In the Matter of)	
)	
Amendment of Part 27 of the)	
Commission's Rules to Govern the)	WT Docket No. 07-293
Operation of Wireless Communications)	
Services in the 2.3 GHz Band)	
)	
Establishment of Rules and Policies for the)	IB Docket No. 95-91
Digital Audio Radio Satellite Service in the)	GEN Docket No. 90-357
2310-2360 MHz Frequency Band)	RM No. 8610
)

REPLY COMMENTS OF XM RADIO INC.

March 17, 2008

Figure 1 New York City Repeater Coverage Map

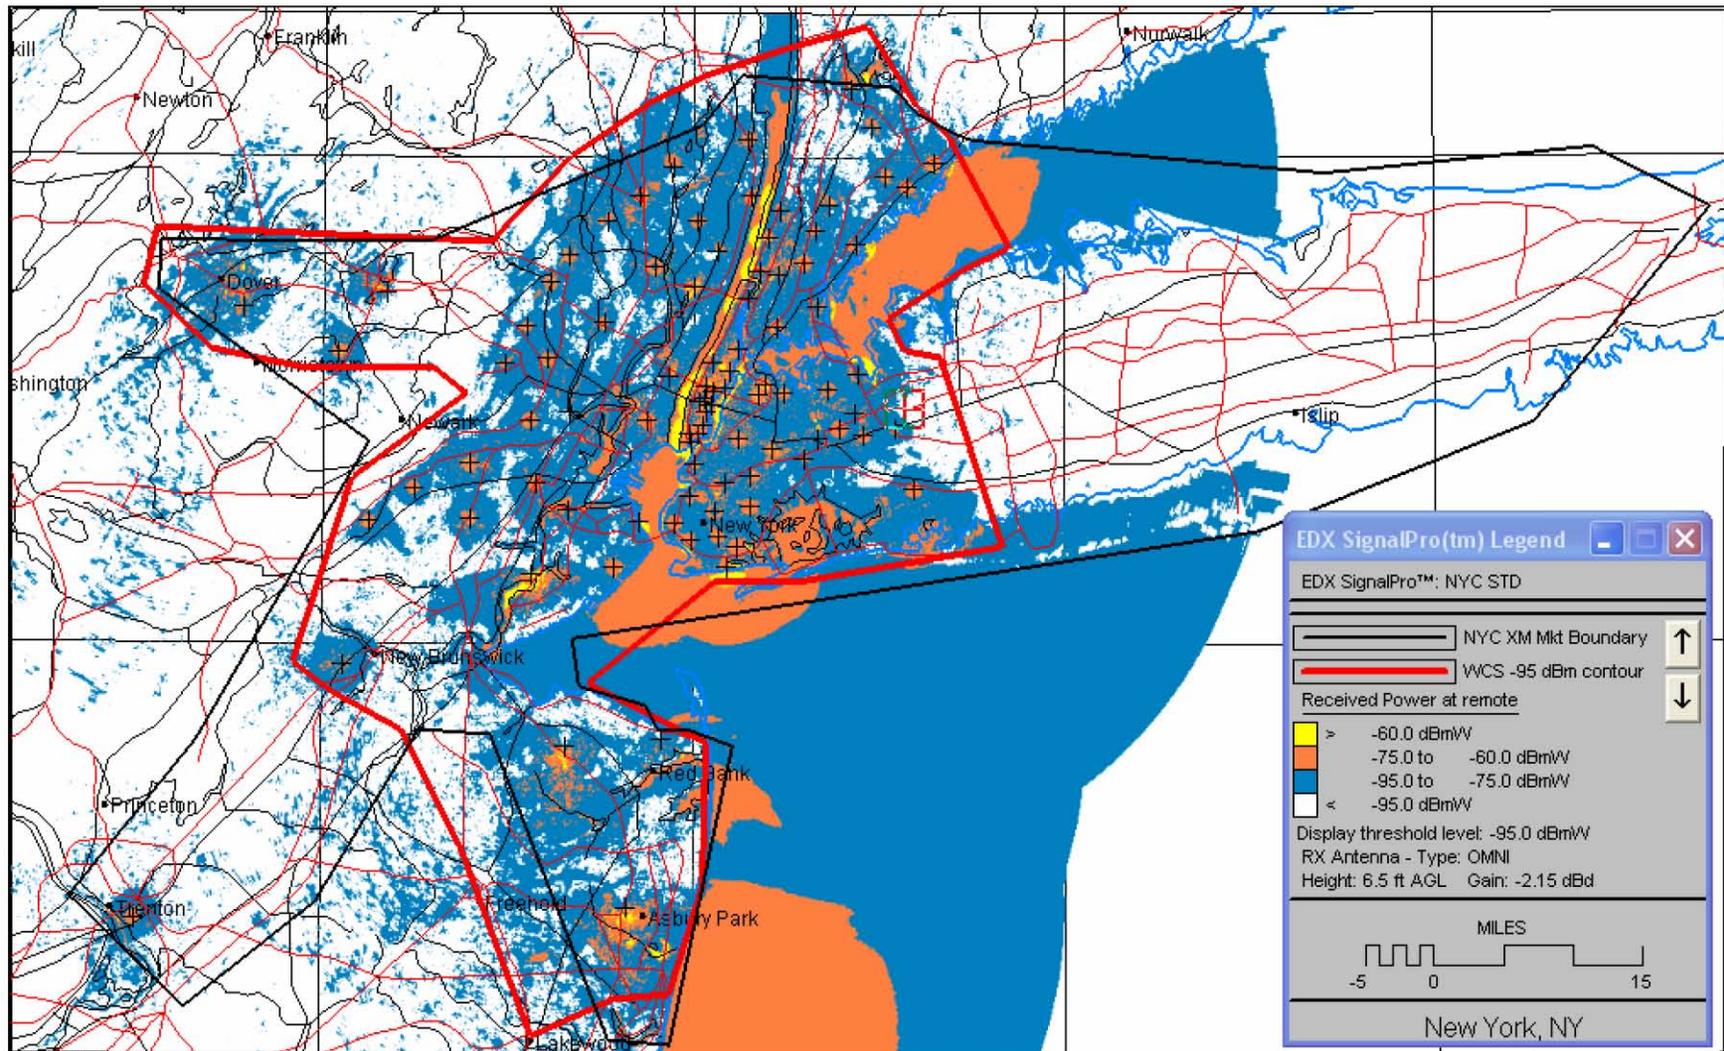
Second, the power level of these repeaters on the ground is much lower than the WCS Coalition suggests. In each case, XM has indicated the area in which its repeaters deliver greater than -60 dBm service, the level chosen because that is the service level needed to provide three meters of protection to SDARS receivers. The WCS Coalition suggests that such zones somehow would be very large. As can be seen, however, actual tests along major city routes demonstrate that XM repeaters exceed that level only in very small areas generally directly at the repeater location.

To correct a number of significant errors and omissions in the WCS Coalition’s analysis, XM has provided its own engineering analysis of the same markets along with specific details on the models and analysis used. XM’s study is based on engineering models whose accuracy has been confirmed by measured data in extensive field tests. XM relies on these models to determine where repeaters are necessary to ensure continuous service to our customers, and where it can rely on service from its satellites and avoid the significant expense of repeater deployment and operation.

Figure 4 New York City Market Predicted Ground Based Signal Levels ≥ -44 dBm

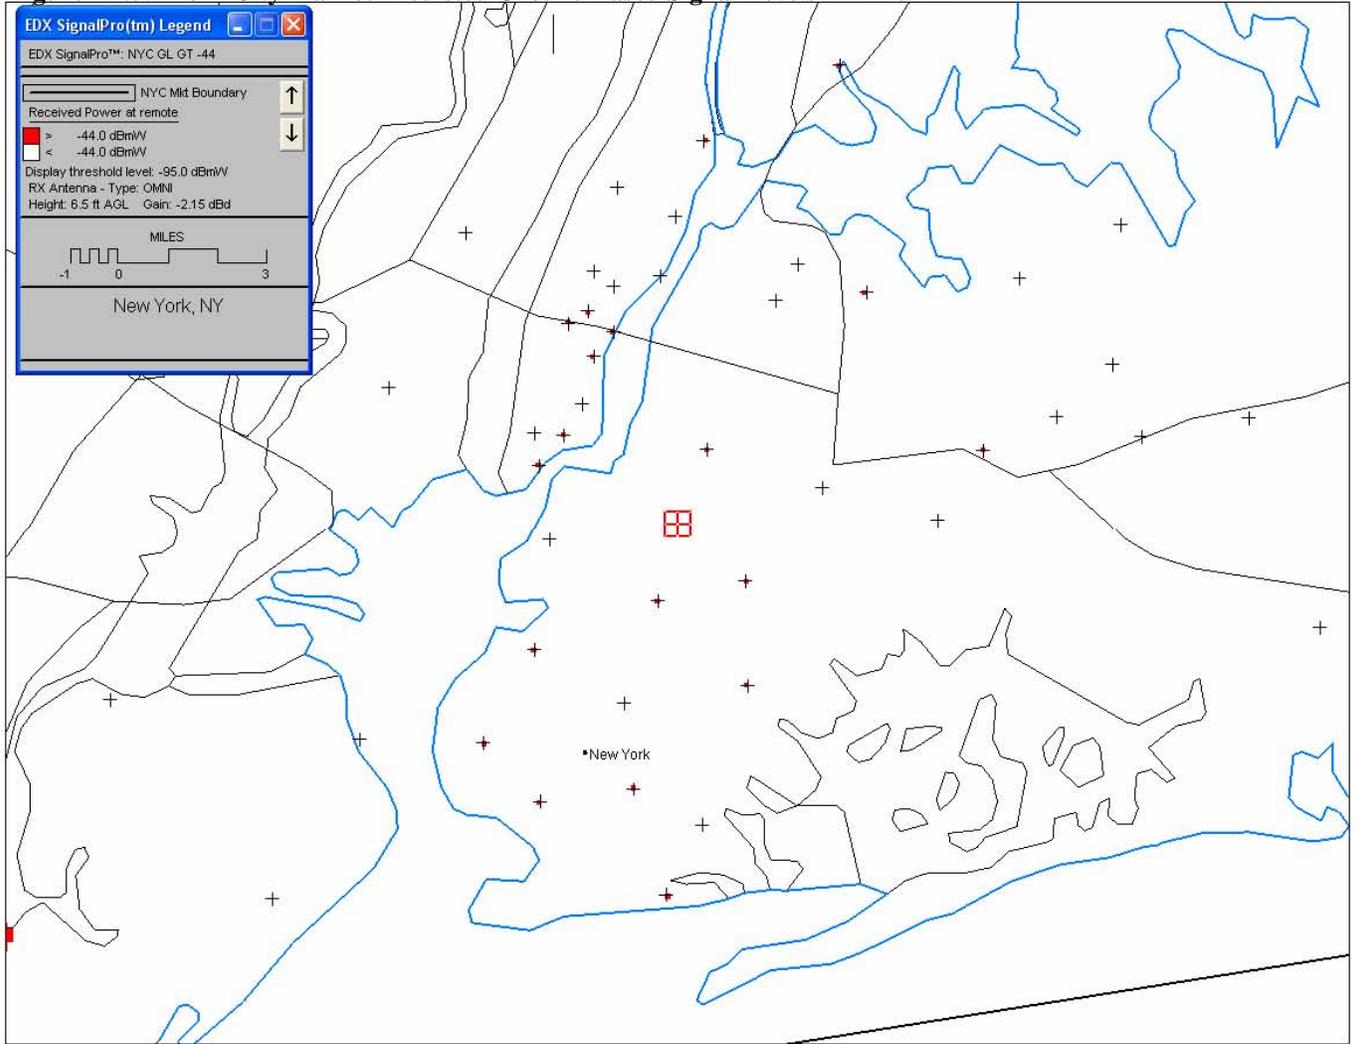
XM's modeled data provide a stark contrast to the maps supplied by the WCS Coalition. XM's coverage maps show the same geographic areas, but with far smaller areas where power exceeds -45 dBm. XM's measured data confirm these results. As previously discussed, these measurements were taken on-site and have to be highly accurate because they are used for planning and construction of repeaters. The maps produced as a result of this testing show very few instances of terrestrial repeater power at -45 dBm or above.

Note that there are very few areas on the map with signal levels > -44 dBm. . '+' represents repeater locations.

Figure 5 New York City Market Drive Test Signal Level Measurements

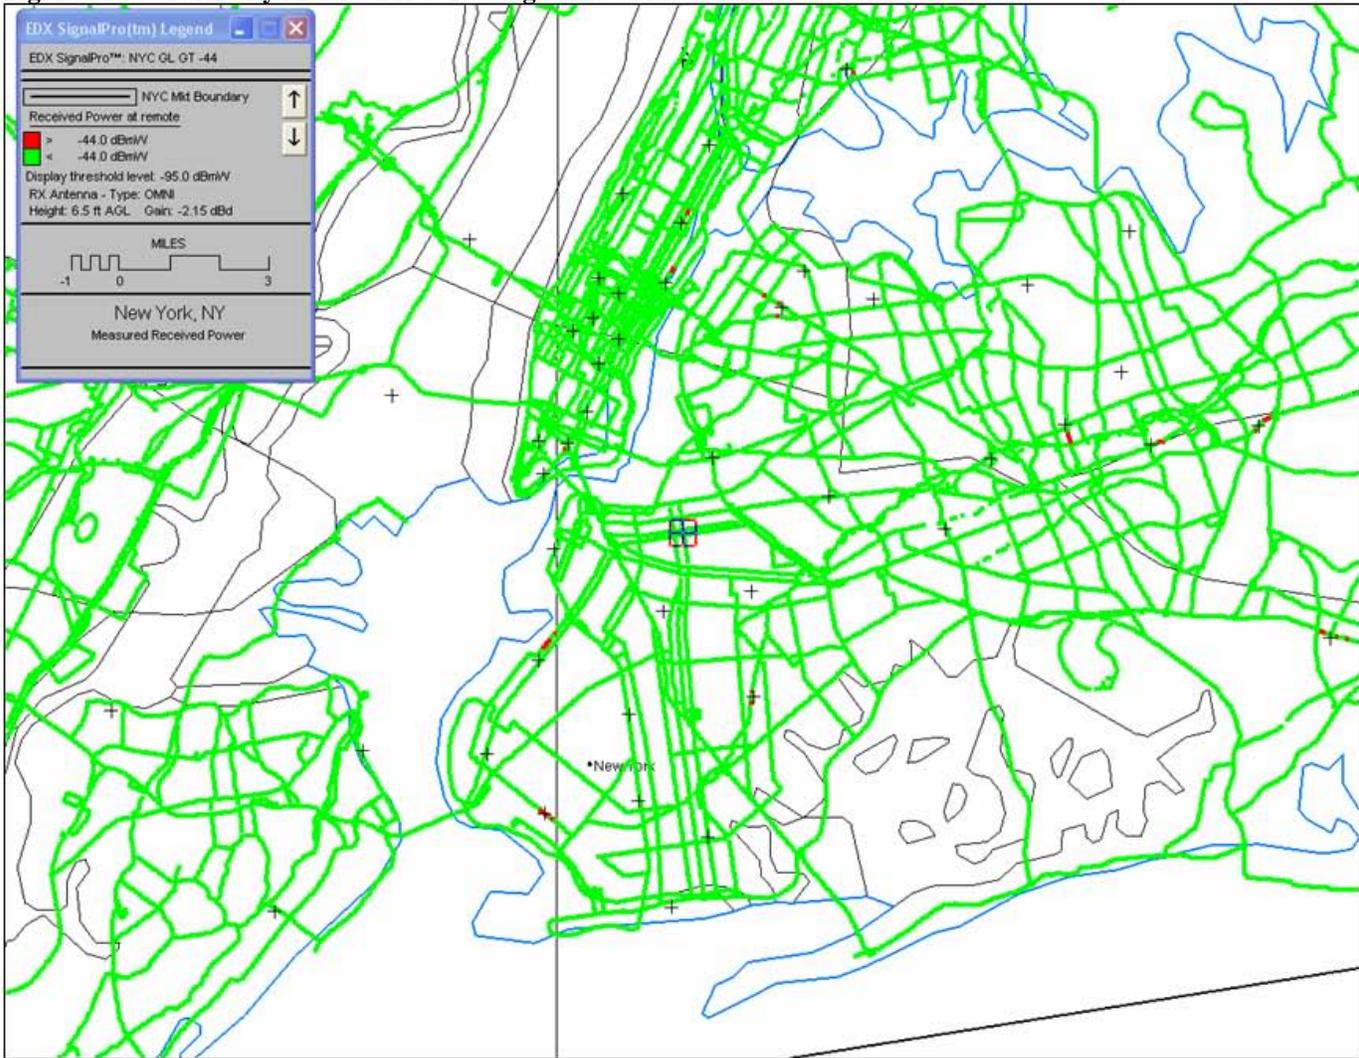
Note that very few of the measurements have signal levels > -44 dBm. '+' represents repeater locations.

Figure 7 Washington, DC Market Predicted Ground Based Signal Levels Showing Ground Based Levels ≥ -44 dBm

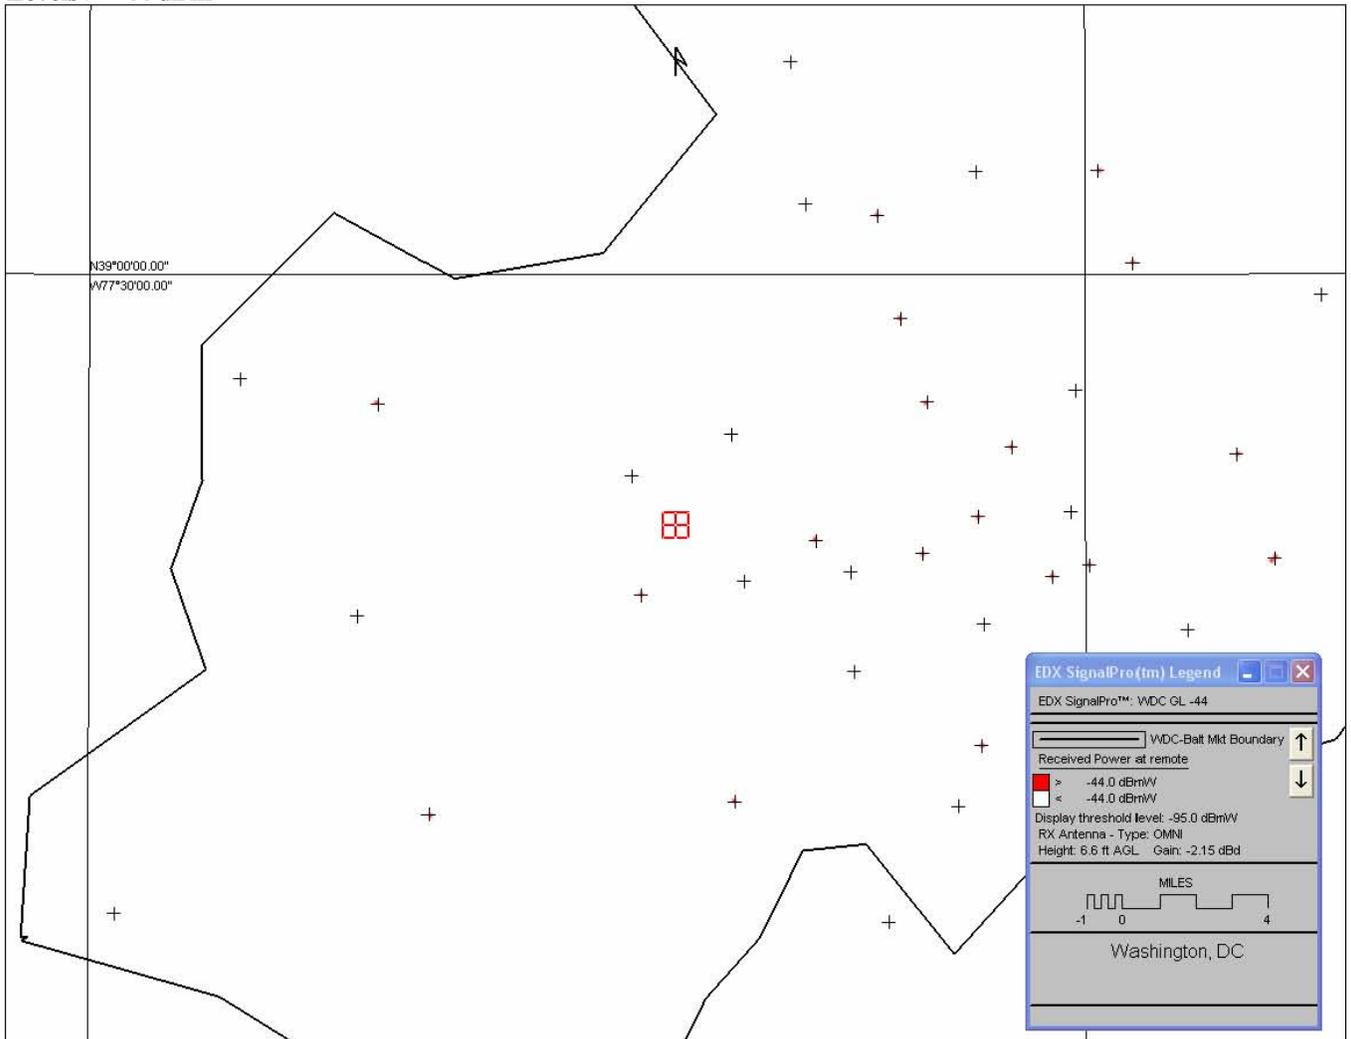
Note that there are very few areas on the map with signal levels > -44 dBm. '+' represents repeater locations.

Figure 8 Washington, DC Market Drive Test Signal Level Measurements

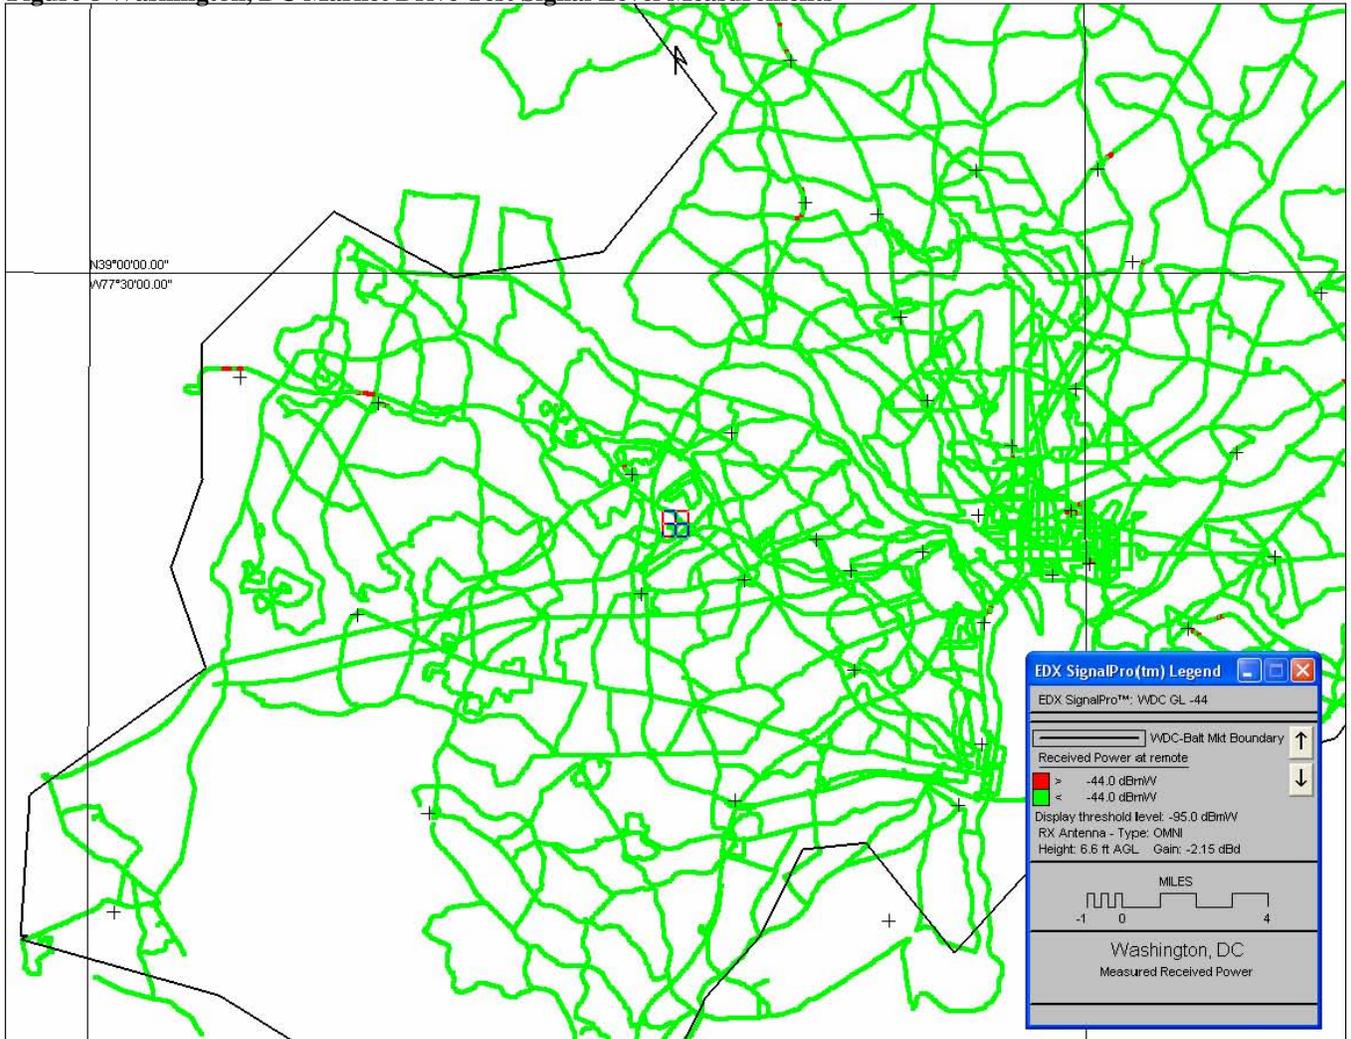
Note that very few of the measurements have signal levels >-44 dBm. '+' represents repeater locations.

Figure 100 New York City Comparison WCS Base Station 30 m Receive Levels > -40 dBm

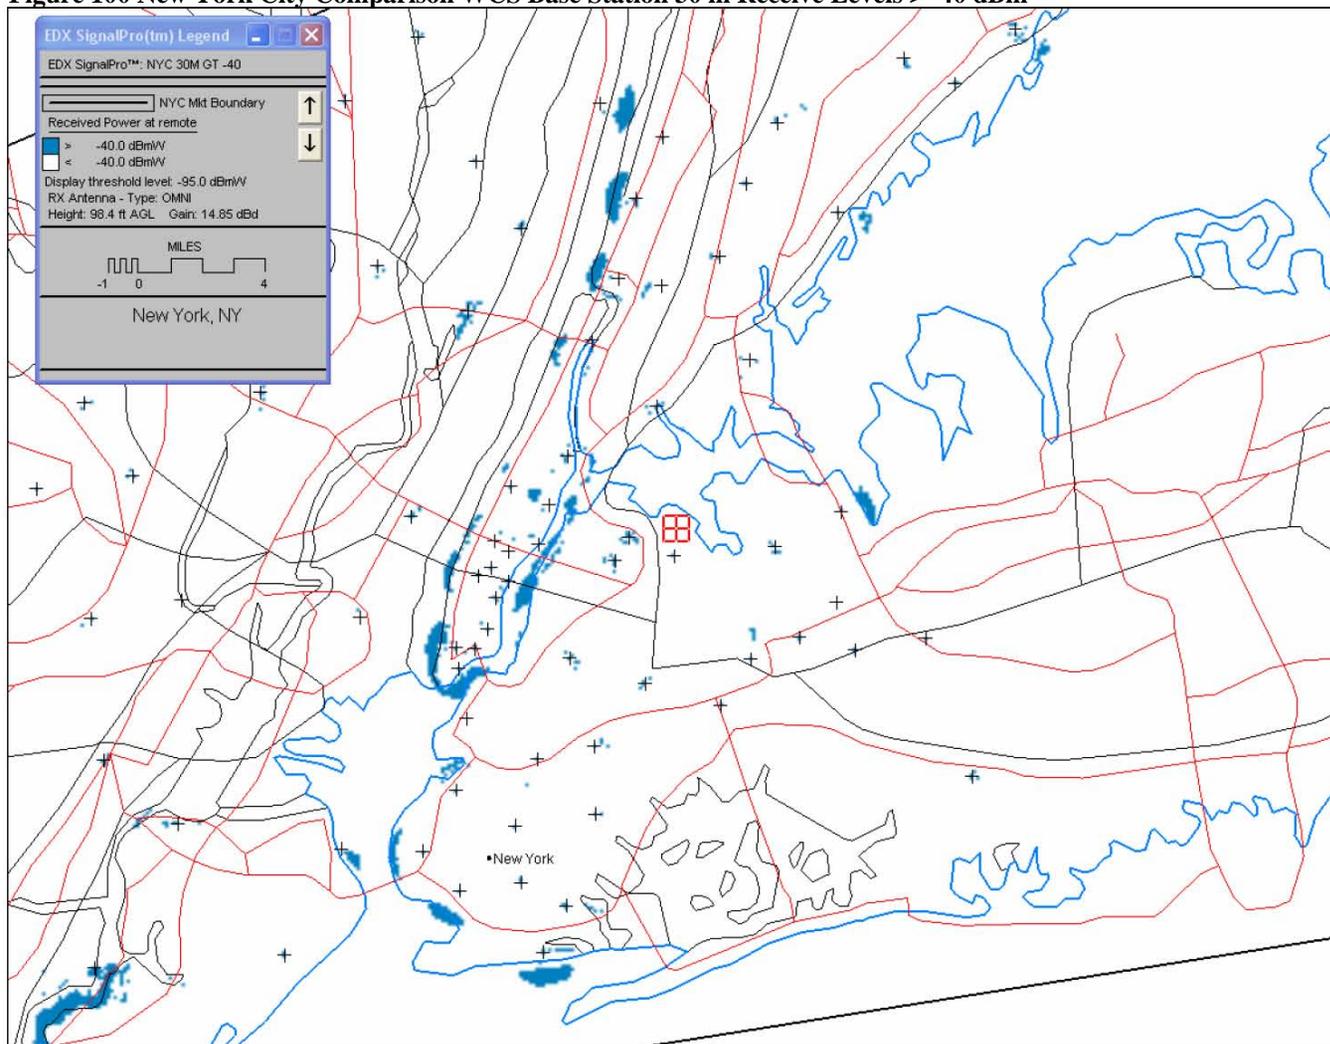
The blue areas show the predicted XM terrestrial signal level > -40 dBm at the WCS base station antenna terminal, 30 m AGL.

Figure 111 Washington, DC Comparison WCS Base Station 30 m Receive Levels > -40 dBm

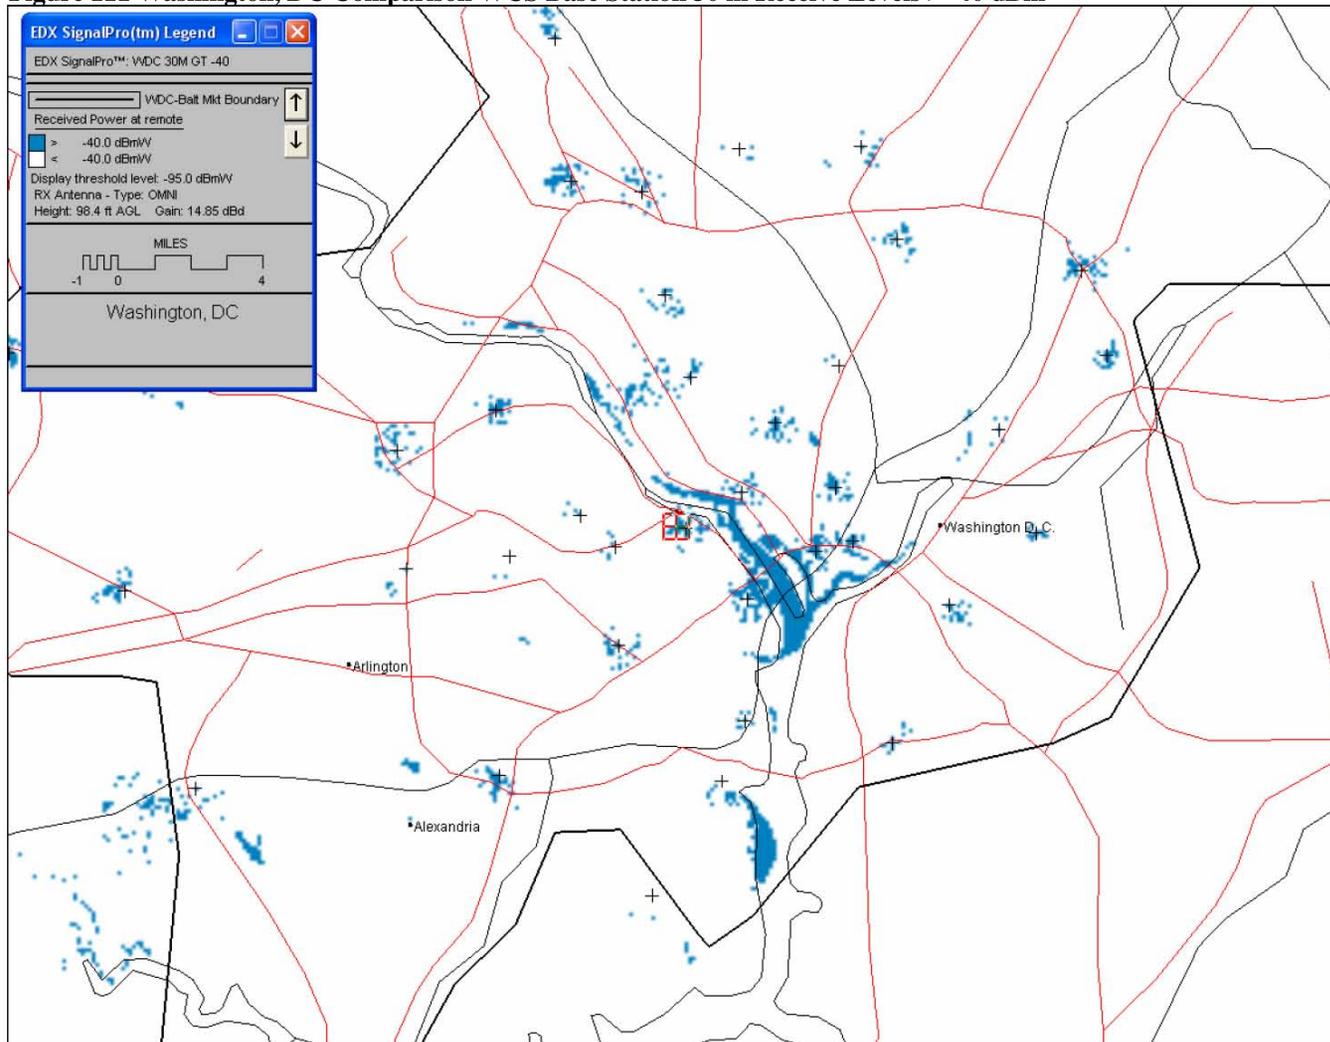
The blue areas show the predicted XM terrestrial signal level > -40 dBm at the WCS base station antenna terminal, 30 m AGL.
